May 21, 2020

**Re: Permit No. M-1980-244; Cripple Creek & Victor Gold Mining Company; Cresson Project; –
Technical Revision 121 Preliminary Adequacy Review Response**

**FIGURE 3:
PROPOSED AREA**

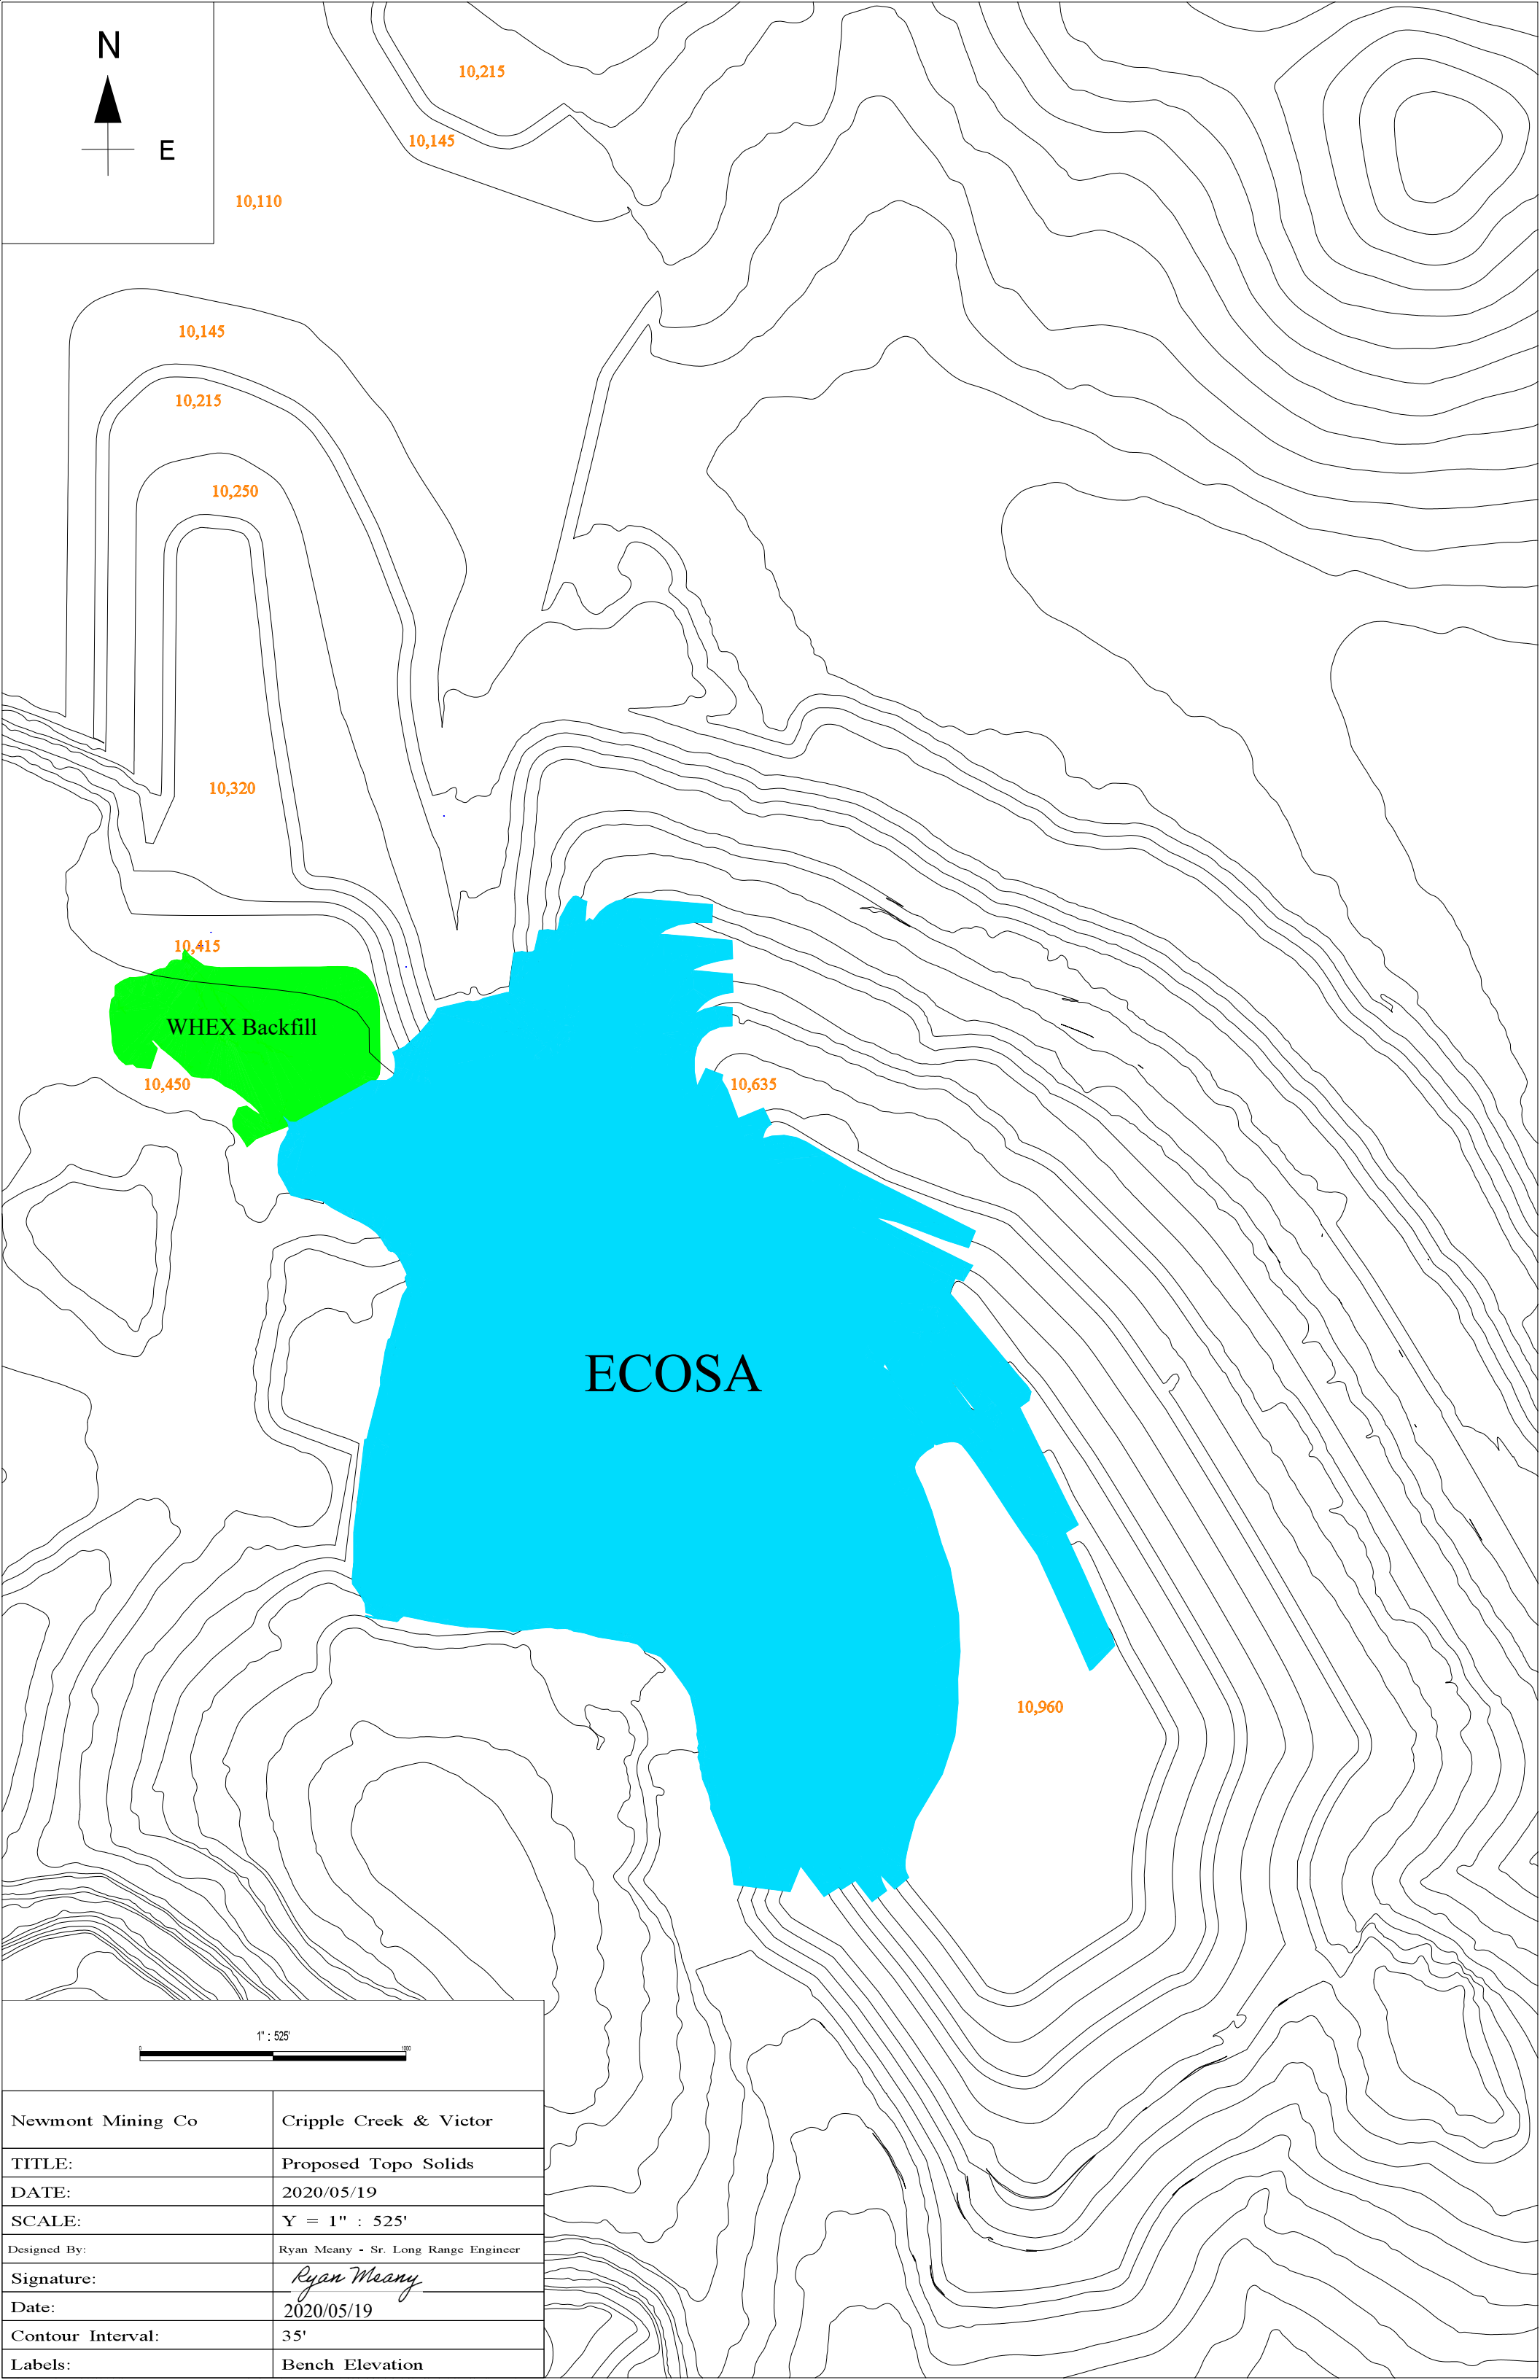
- 3) *Figures/Drawings: The provided drawings may be appropriate for internal mine planning, but more information and clarification are necessary to convey the full intent of the proposed changes. For example: there are no legends on any of the figures/drawings as required by Rule 6.2.1; and there appear to be inconsistencies with drawings submitted as part of AM-13 (which the Division is currently reviewing). Attached to this adequacy letter are markup versions of the four submitted drawings. Please revise the four drawings accordingly.*

Enclosed in this response, Figures 1-4 have been updated to address DRMS comments.

FIGURE 4:
POST-RECLAMATION TOPOGRAPHY

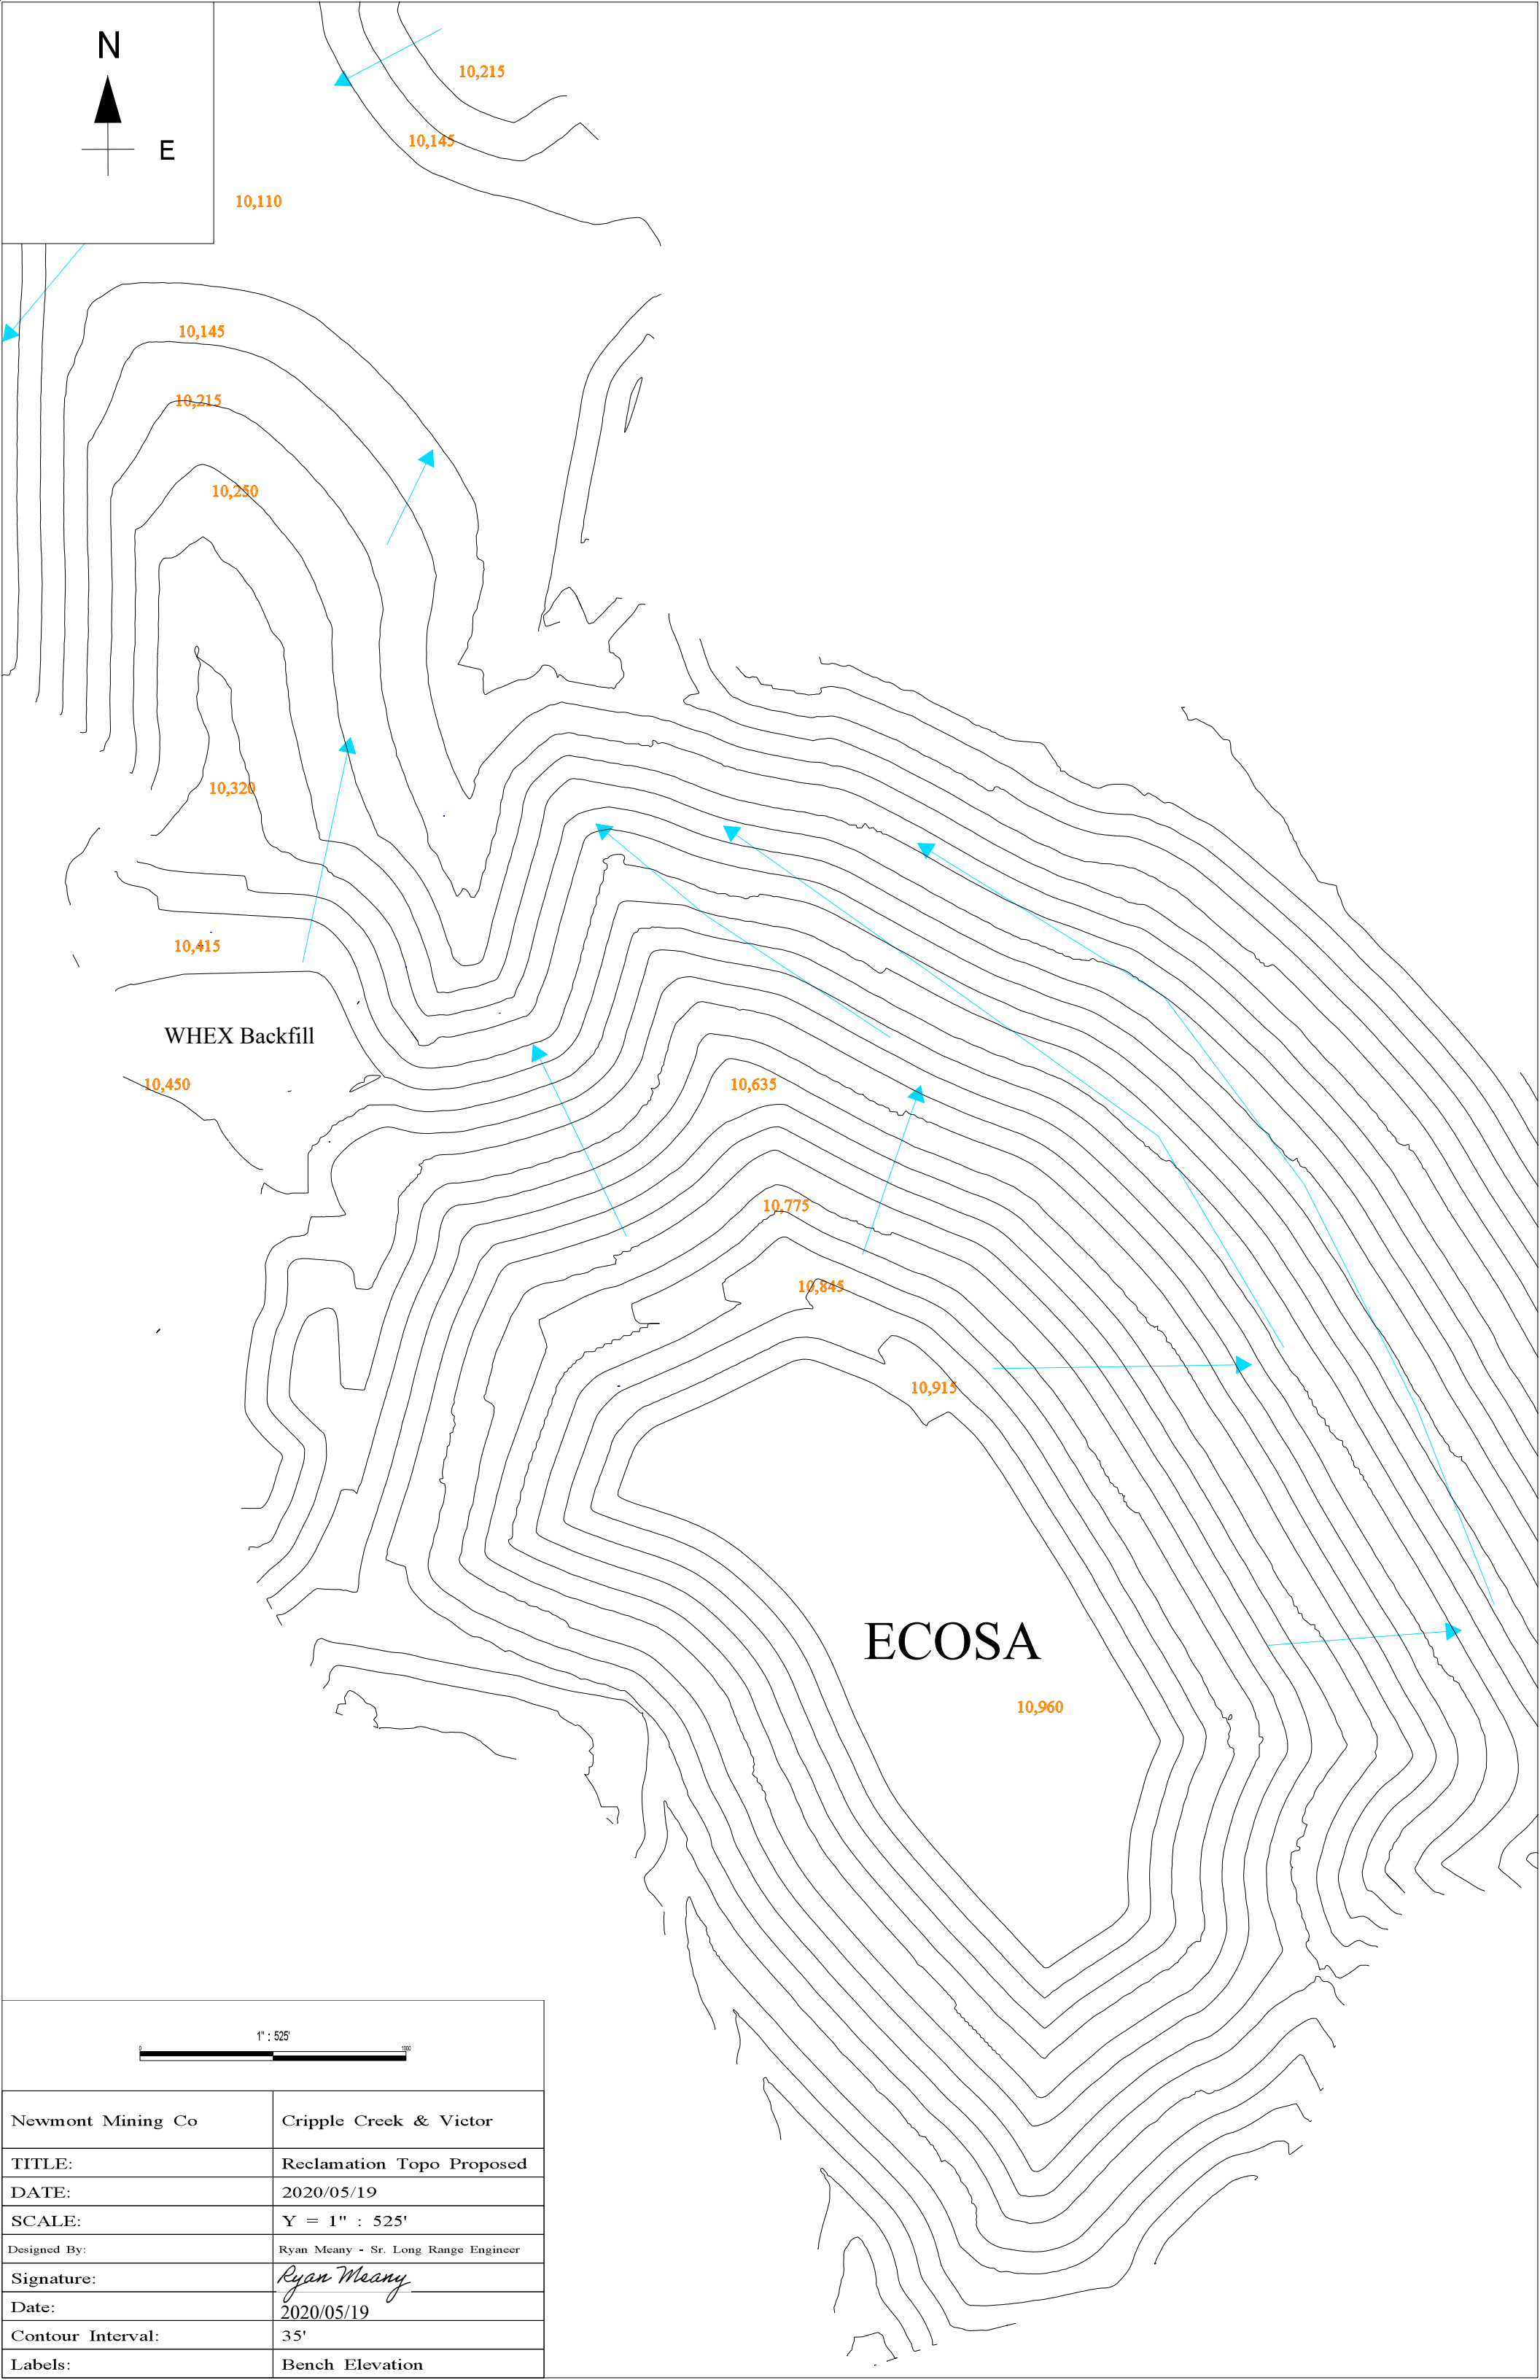
- 1) *Drainage: The second paragraph on p. 2 states "all drainage flow will be directed to the WHEX pit or existing management structures". AM-13 stormwater plans show some runoff directed towards Grassy Valley. Please also note drawing markups referenced in Comment 3 below. As this TR has been submitted in parallel with AM-13, it must be consistent.*

Figure 4 (enclosed) has been updated to include drainage flow. Drainage flow from the ECOSA that is not directed to the WHEX pit, will be directed to one of several Enhanced Management Ponds (EMPs) in Grassy Valley, as approved in Amendments 10 and 11 and Technical Revision 101. As discussed with DRMS via phone on April 29, 2020, CC&V plans to submit a TR to address all DRMS comments contained in the Stormwater Preliminary Adequacy Review, Amendment 13 application (AM-13). Pending DRMS approval of this TR, the stormwater flows included in the proposed topography will be reflected in this TR, addressing the aforementioned Stormwater Preliminary Adequacy Review.
